**RE: Kinross Gold Corporation, Lupin Mine, Contwoyto Lake, NU.
Water License NWB1LUP0008
2006 Annual Geotechnical Report**

KINROSS GOLD CORPORATION LUPIN OPERATION

2006 GEOTECHNICAL INSPECTION PERIMETER TAILINGS DAMS

**RE: 2006 REPORT ON ANNUAL GEOTECHNICAL INSPECTION
PERIMETER TAILINGS DAMS, LUPIN MINE, NUNAVUT**

PROJECT	ANNUAL INSPECTION OF PERIMETER TAILINGS DAMS	TITLE
DAM 4 INSPECTION PHOTOS		
PROJECT NO.	FIGURE NO.	REV.
0256-012-01	10	0

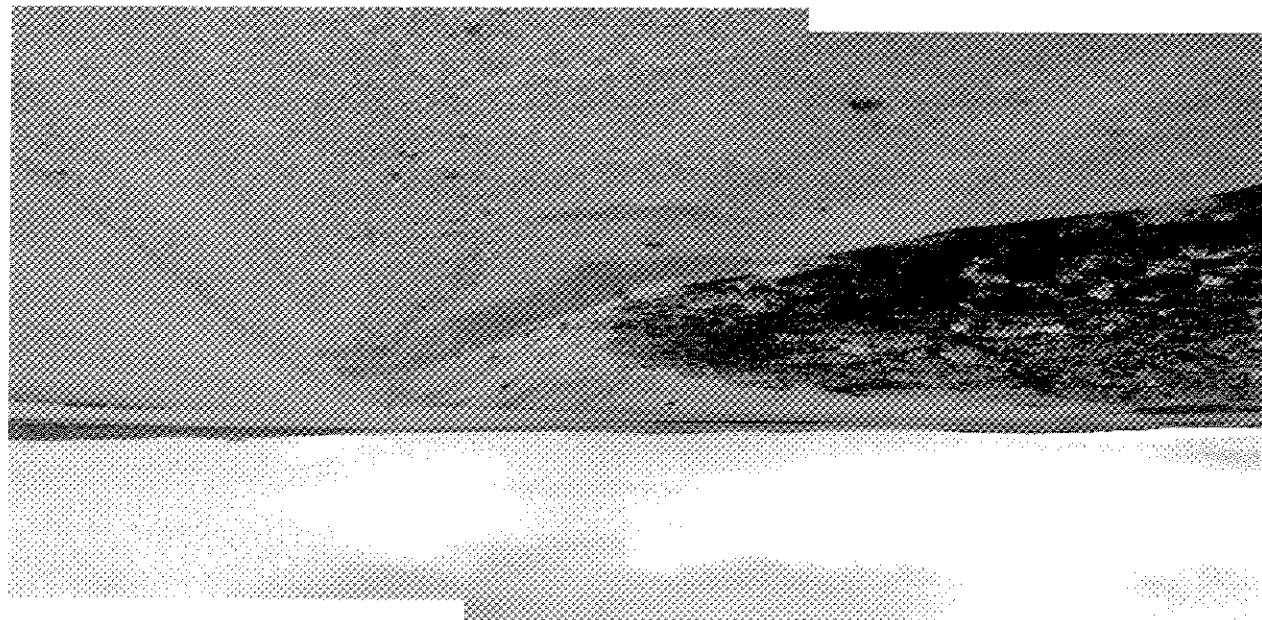
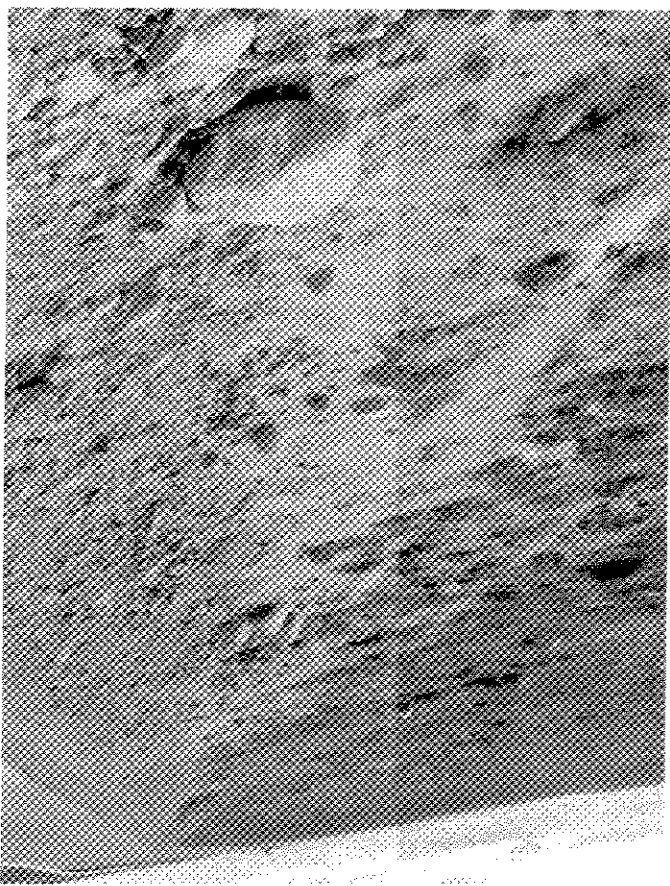
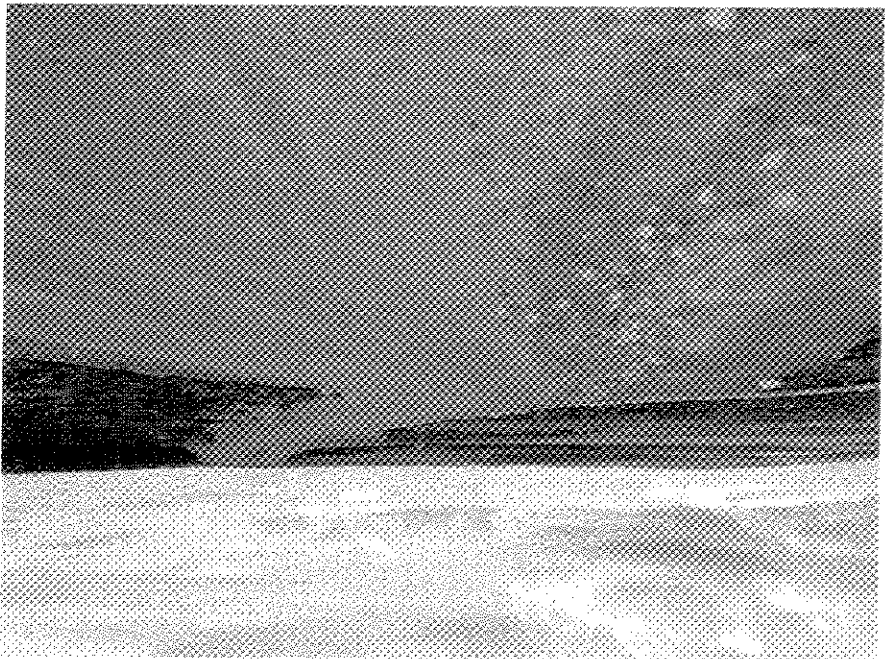
Show several erosional gullies located on the downstream edge of the crest.

Shows an erosional gully right at the west abutment of this dam. This gully tends to stem from an uphill ditch which focuses the erosional forces of water from the slope above.

- Numerous small to mid-sized erosional gullies located on the downstream side of the crest should be backfilled to prevent additional erosion. One larger sized one is located towards the west abutment where surficial runoff water from the crest is funneled at one point. Some grading required to prevent this from occurring again.
- No other concerns noted or maintenance required.

The crest at the west abutment should be graded and the erosional gullies on the downstream slope should be backfilled to prevent additional erosion.

PROJECT	ANNUAL INSPECTION OF PERIMETER TAILINGS DAMS
TITLE	DAM 6 INSPECTION PHOTOS
PROJECT No.	02566-012-01
FIGURE No.	12
REV	0

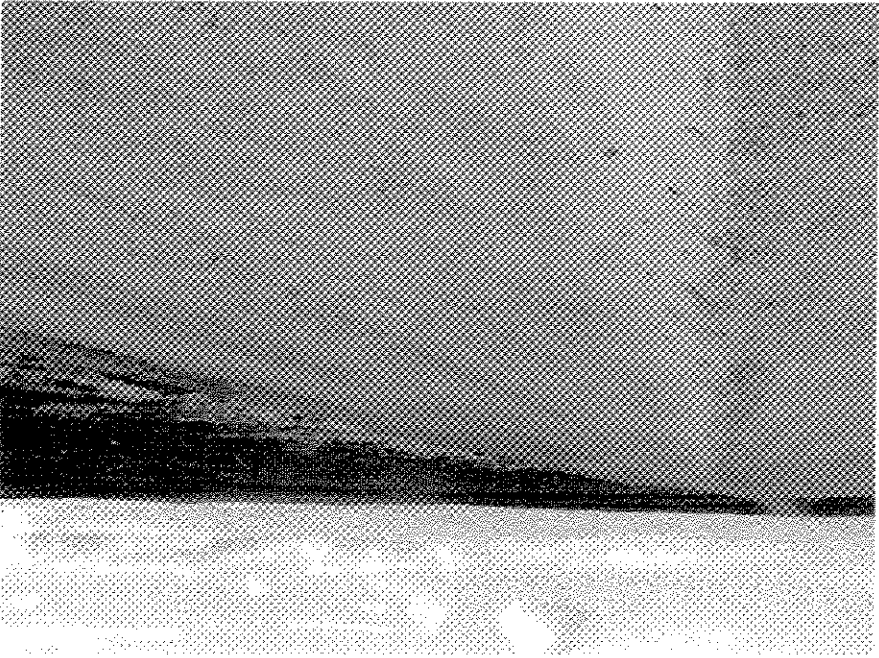
Shows some longitudinal cracks within the fill material located in the berm.

Shows longitudinal cracks located at the downstream toe of the fill.

- Three minor erosional gullies and some minor longitudinal cracking were noted at the toe.
- A small pond has been formed on the upstream side of this dam, at the south abutment, due to proximal cover placement trapping runoff against the natural topography. The placement of additional esker material over an area of 80 to 100 m² would prevent the formation of this pond, reducing the risk of overtopping or seepage.
- No other concerns noted or maintenance required.
